Re: Groundwater Remediation
Proposed 2015 Action Plan – Response Letter
Case No. 1987-2534-KE
Chester River Hospital Center
100 Brown Street, Chestertown
Kent County, Maryland
Project No. 14004.00

This is in response to Maryland Department of the Environments (MDE's) letter dated March 27, 2015 regarding comments on the proposed 2015 Action Plan. The specific purpose of this Shore Regional Health Chester River Hospital Center (SRH-CRHC) response letter is to both address the MDE comments and to revise the 2015 Proposed Action Plan as required.

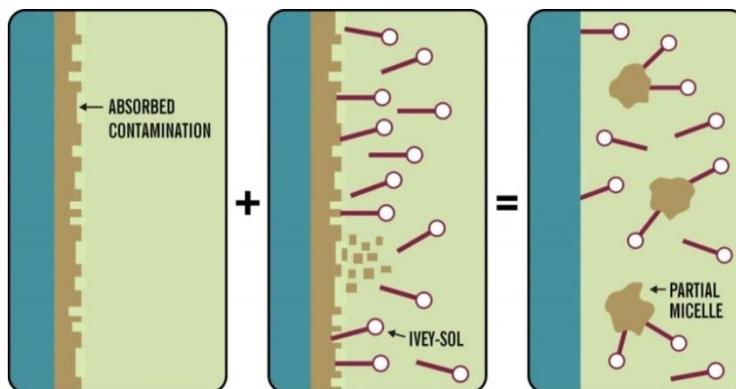
- i. *What exactly was observed that was determined to be "biological activity"? Any photos?*

A film appeared on the bag/MyCelx® filters during the extraction process. Since the extraction water was clear and had no evidence of particles or turbidity, it is assumed that TPH-DRO liberated was dissolved and became available for microbial action. Rapid growth of these microorganisms appeared on the surface area of the bag/MyCelx® filters much like the surface area on a trickling filter which became a good environment for microbial growth. Attachment B includes pictures of the growth on the bag/MyCelx® filters.

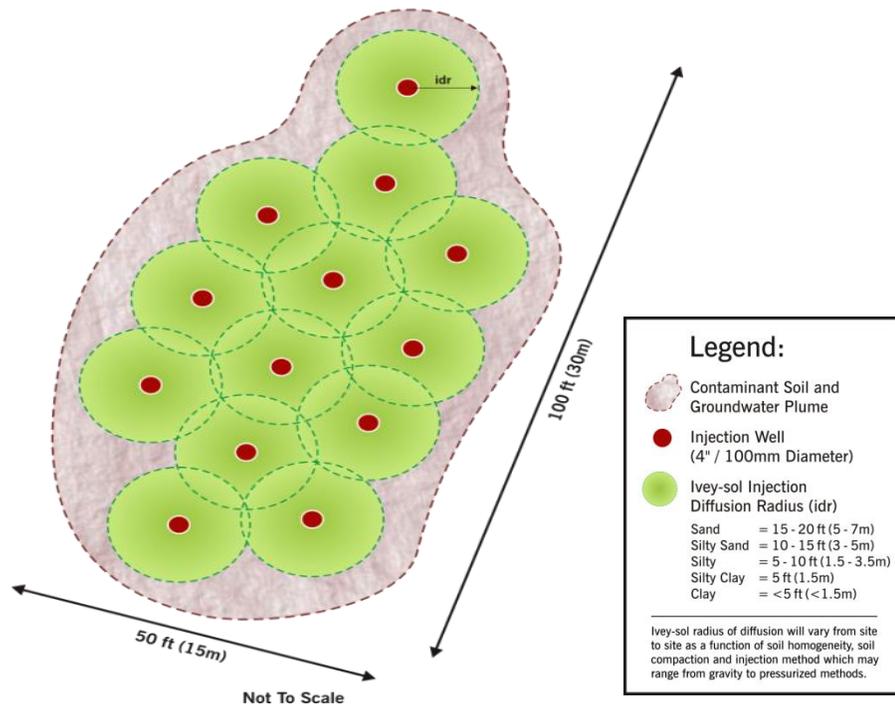
a. Table 1 - This paragraph suggests that mounding occurred in the injection wells. Looking at the data presented in Appendix D, Table 1 and the cross sections presented in Appendix G, it appears that at least in the case of MW-42 and MW-22 that the observed mounding appears to be a factor of well construction. The highest measured elevations, taken about 30 minutes after the injection commenced, were about 5.5 feet above the elevation of the well screen and the observed mound appeared to dissipate within approximately one hour after the injections. Further there was approximately 5 feet of screen above the water table in each of these wells prior to the injection commencing. Actual mounding may have been limited to approximately 5 feet and for a limited distance from the well and a limited duration.

IVEY-SOL INJECTION DIFFUSION RADIUS

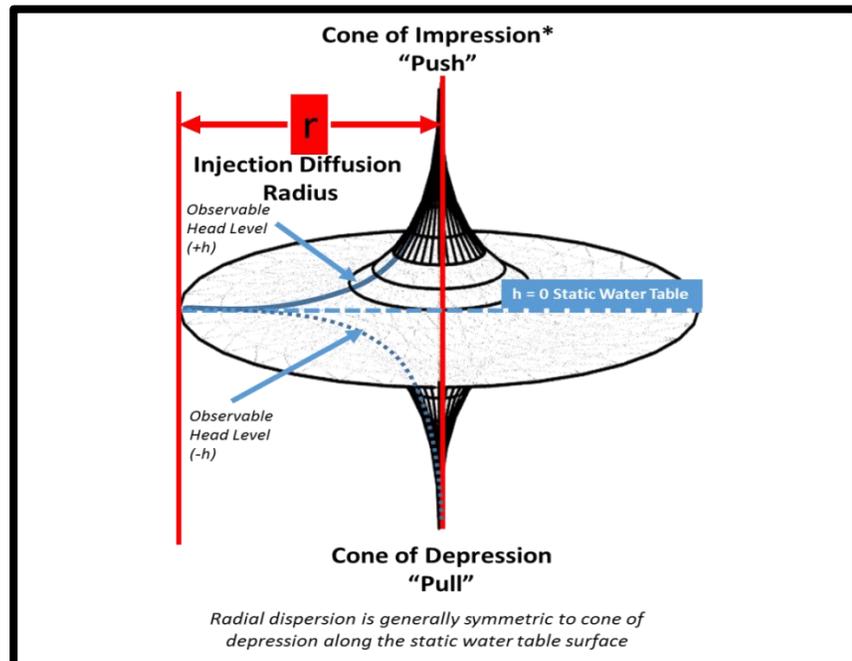
Because the 2015 Action Plan places emphasis on mounding as a success factor for delivering the surfactant, provide a more detailed discussion of the observed mounding. The discussion should include, at a minimum, the following:

- i. Duration of the mounding;*
- ii. Whether mounding was a factor of well construction (i .e. screen depths); and*
- iii. Whether mounding was observed in adjacent wells and at what distances.*

A more technical validation would involve hydraulic monitoring for the standard Injection Diffusion Radius (IDR) of Ivey-sol® for Push-Pull Injection and Recovery in a Single Well Utilizing near-by Monitoring Wells. An Ivey-sol® solution injection volume (Q – which can be increased or decreased to modify IDR) will flow with an increased hydraulic conductivity (K) based on surface tension reductions (i.e. from 73 dynes to < 30 dynes), and have a corresponding lower viscosity than that which are incorporated into the standard K values for groundwater flow, which are the basis of modeling drawdown (a generalized symmetry exists with respect to the cone of impression "Push" and the cone of depression "Pull" at the static water table surface).

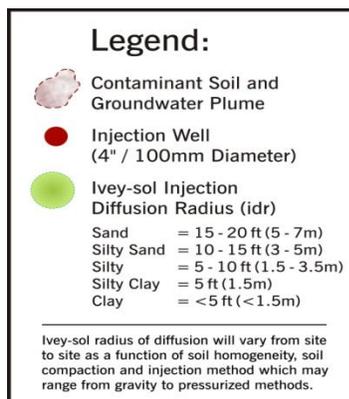
iii. How were the pumping rates for each well incorporated into the radius of influence calculations?

Dupuit Forcheimer equation for radial Flow to a well or point source excavation in an unconfined aquifer is given by:

Using the above equation, the pumping rates for each well were incorporated into the radius of influence calculation.

IVEY-SOL INJECTION DIFFUSION RADIUS

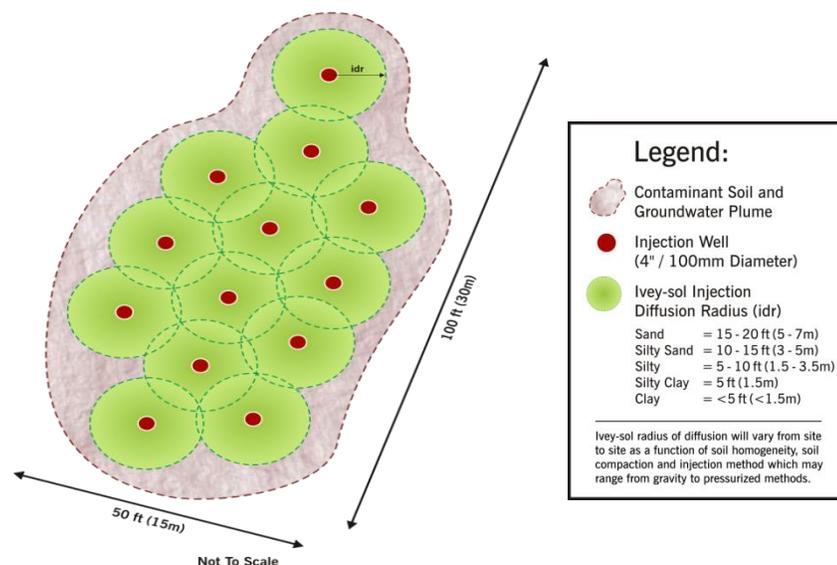
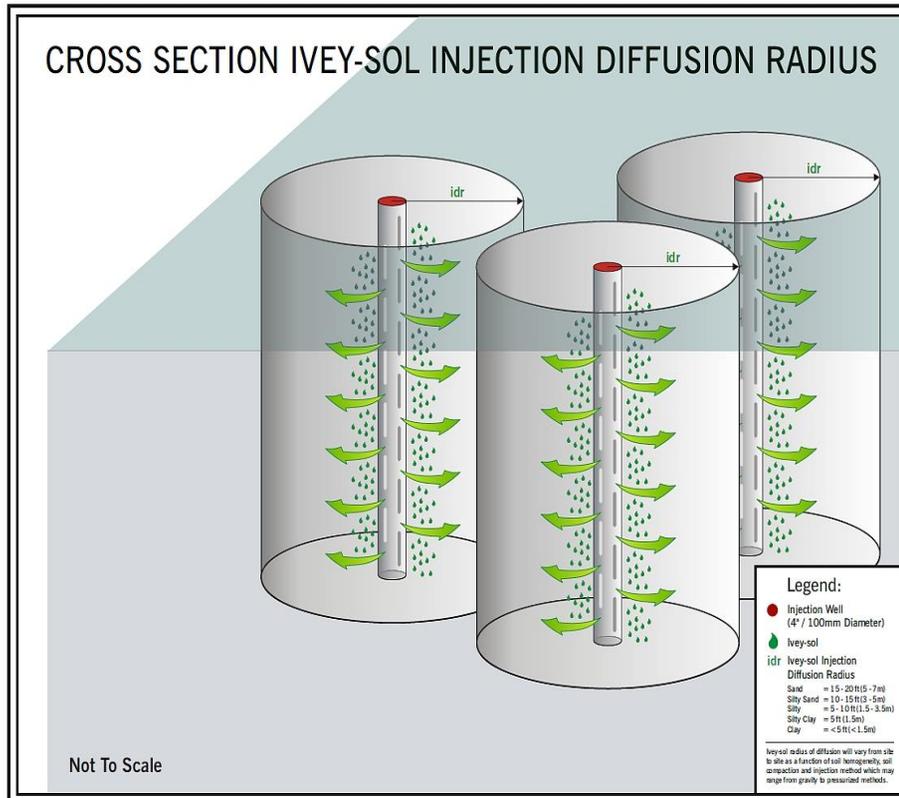
a. Section 5.1.B - The following statement is made, "By achieving a groundwater table mounding on the order of five feet to ten feet in the vicinity of each monitoring well indicated we can target residual TPH-DRO in the unsaturated (vadose) zone onsite if and as required." As commented on previously, the well construction details and gauging data from neighboring wells should be incorporated into this argument. It is not clear that there was anything more than highly localized and short lived "mounding" in the injection well as the slug of surfactant dissipated into the formation. From the data presented, there does not appear to be a way to substantiate just how far into the formation the injected material drained.

The observed mounding affect is a result of well construction and the introduction of Ivey-sol[®] during the push/injection phase of the process. The degree of mounding; however, is not the only factor that characterizes the degree to which Ivey-sol[®] will disperse. Obviously the greater the mounding affect the greater the dispersion rate. But based on Ivey Internationals use of the Ivey-sol[®] process throughout the world, the field experience with dispersion rates is expected to be more reliable than other methods of modeling/predictions and consistent with the exhibit below.

This chart was created to reflect dispersion rates on a twenty-four (24) hour basis. Where the 2015 Action Plan reflects twenty feet to thirty feet (20'-30') it was based on the expected dispersion over a forty-eight (48) hour period.
